LTB01165NAS2

TECHNICAL BULLETIN

Changes are highlighted in blue				
SECTION:				
413-01				
SUBJECT/CONCERN:				
Navigation Map Displayed On Virtual Display Instrument Panel Cluster Is Corrupt/Scrolling				
AFFECTED VEHICLE RANGE:

MODEL:	MODEL YEAR:	VIN:	ASSEMBLY PLANT:	
Range Rover Velar (LY)	2018	704599-769219	Solihull	
MADKETC

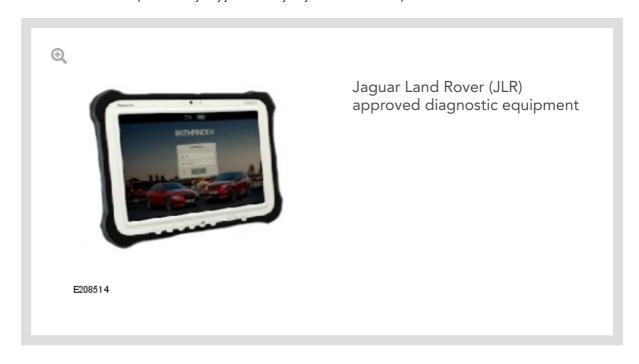
The navigation map display in the center of the virtual display IPC is corrupt and moves/scrolls vertically up the display.

Software error within the IPC.
